THE HIGHLINE AT UNION MARKET

320 FLORIDA AVENUE, N.E.
WASHINGTON DC

May 01, 2016
PUD MINOR MODIFICATION FOR PUD 15-01

P-2 GARAGE PLAN - APPROVED & PROPOSED

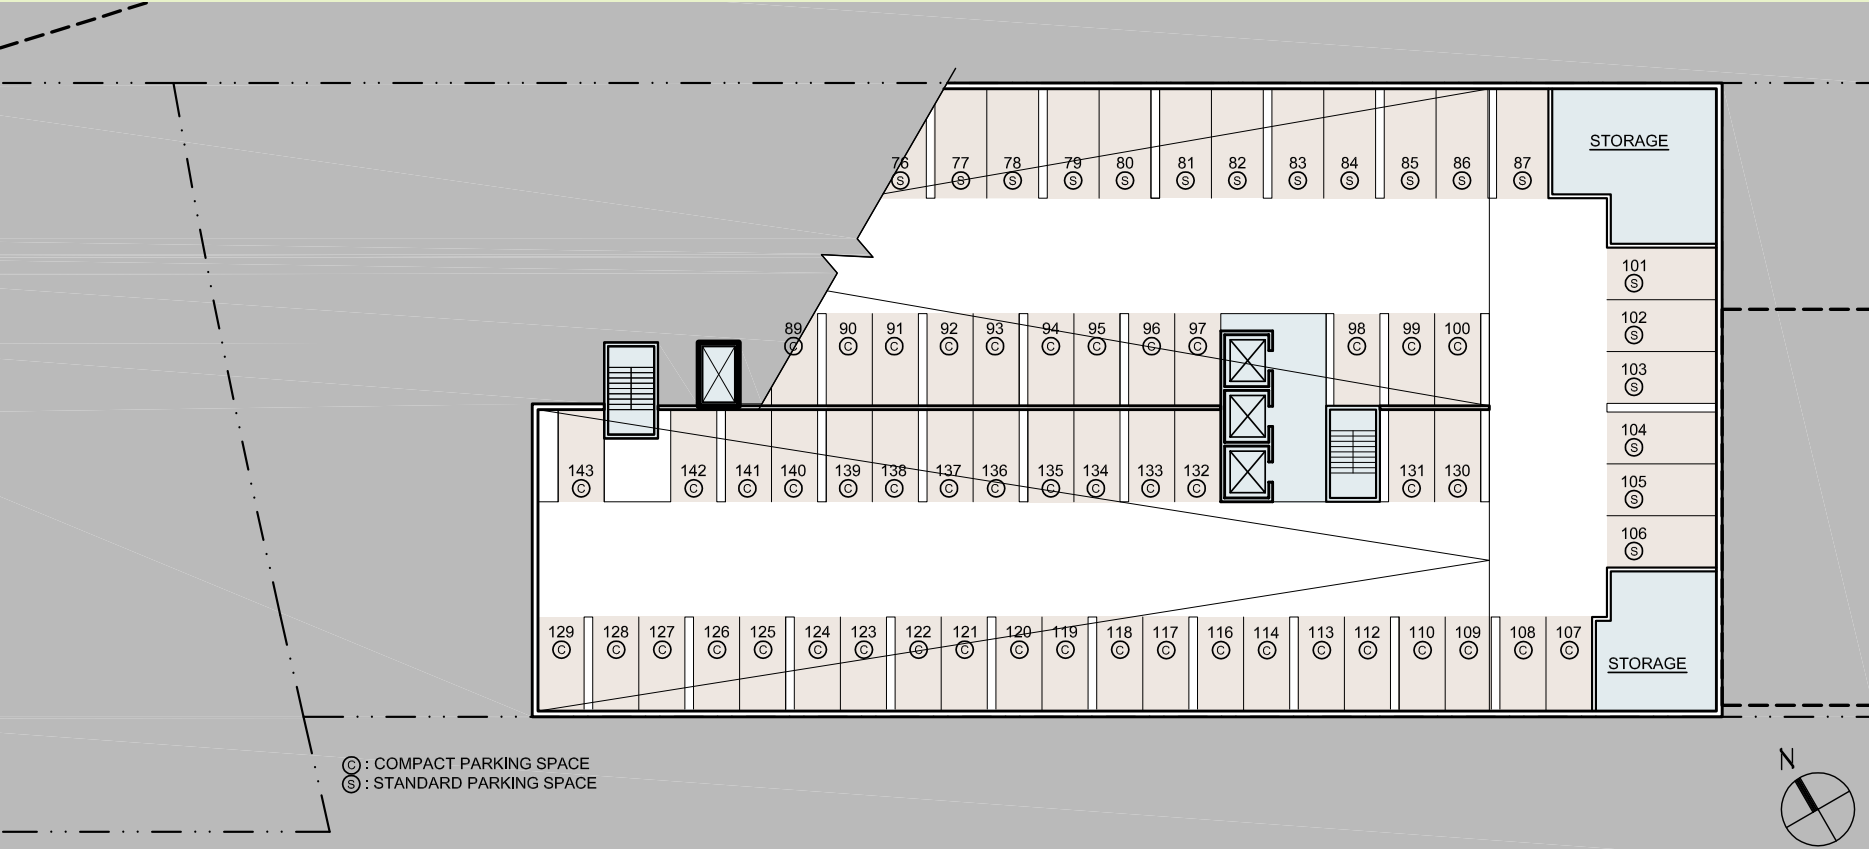
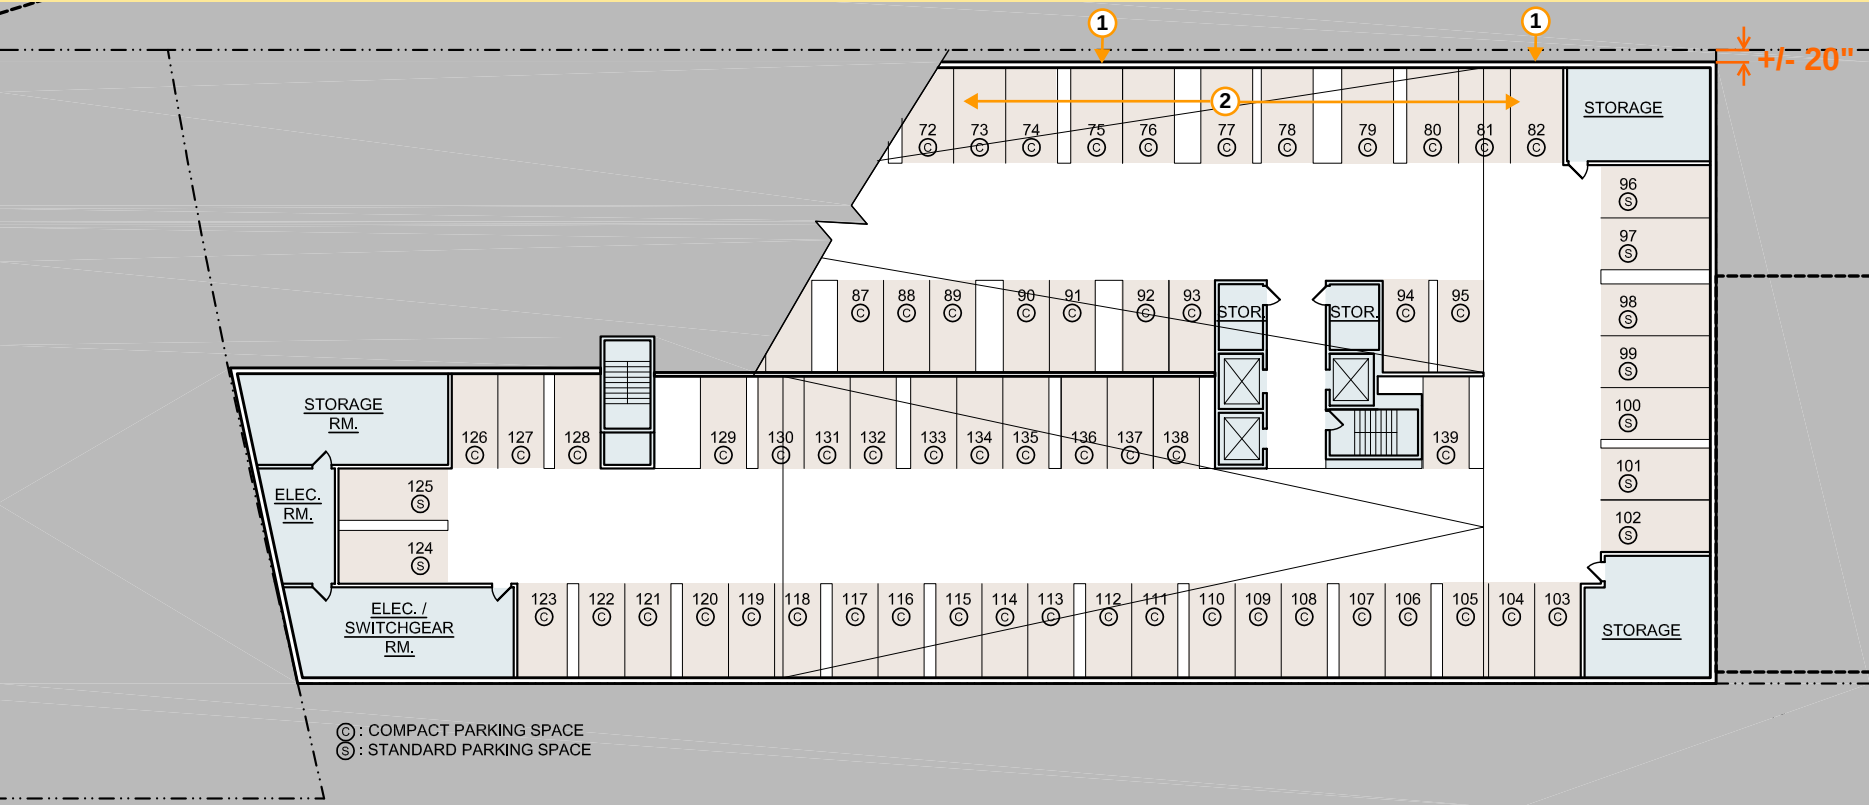
* COMPACT PARKING RATIO INCREASED FROM 63% TO 86%, REPRESENTING ADDITIONAL RELIEF REQUIRED, DUE TO NECESSARY SHIFT IN FOUNDATION WALL. ADDITIONAL COMPACT SPACES WILL MAINTAIN STANDARD PARKING SPACE WIDTH OF 9ft.

1. FOUNDATION WALL SHIFT +/- 20"
2. 9 ft WIDE COMPACT PARKING SPACES

P-1 GARAGE PLAN - **APPROVED** & **PROPOSED**

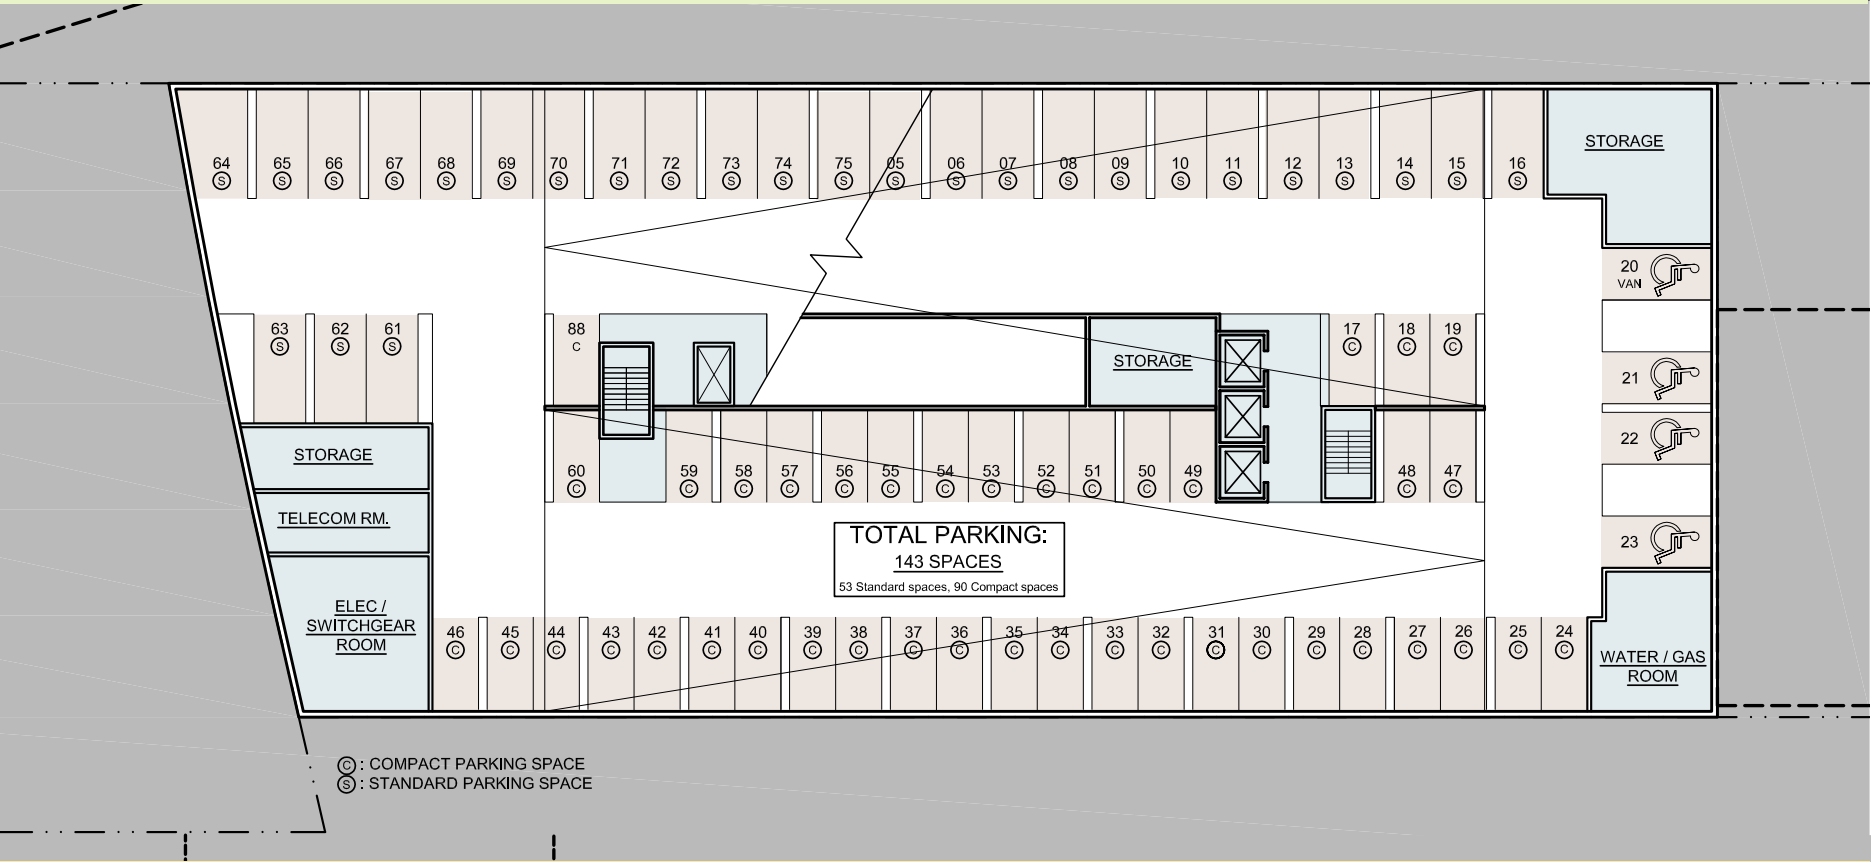
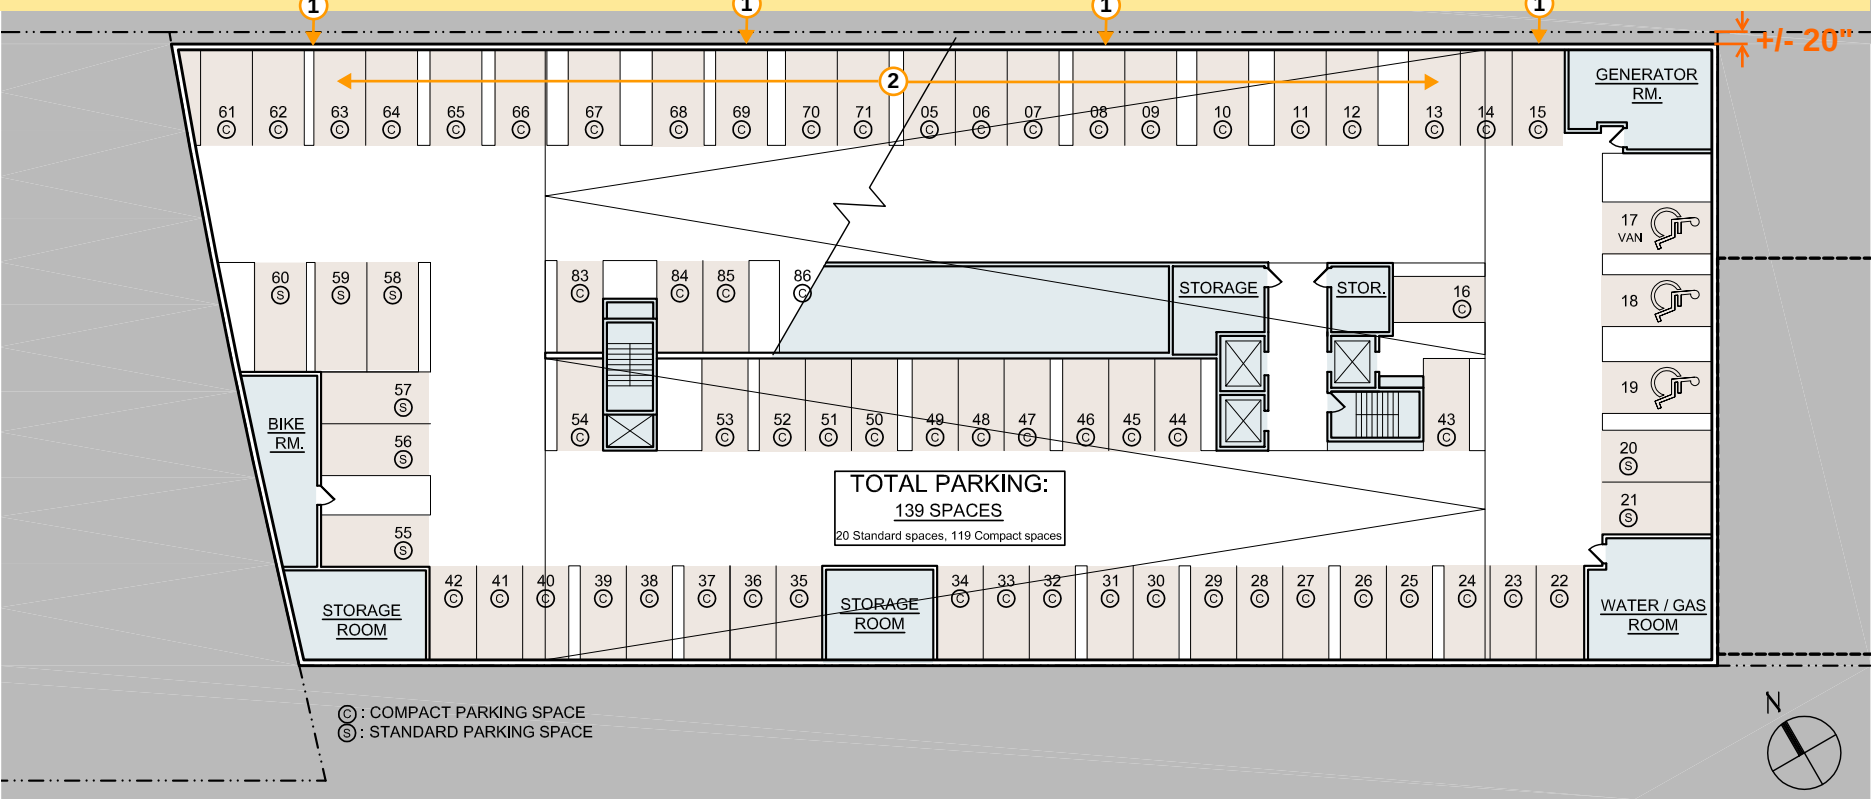
- * COMPACT PARKING RATIO INCREASED FROM 63% TO 86%, REPRESENTING ADDITIONAL RELIEF REQUIRED, DUE TO NECESSARY SHIFT IN FOUNDATION WALL. ADDITIONAL COMPACT SPACES WILL MAINTAIN STANDARD PARKING SPACE WIDTH OF 9ft.
- 1. FOUNDATION WALL SHIFT +/- 20"
- 2. 9 ft WIDE COMPACT PARKING SPACES
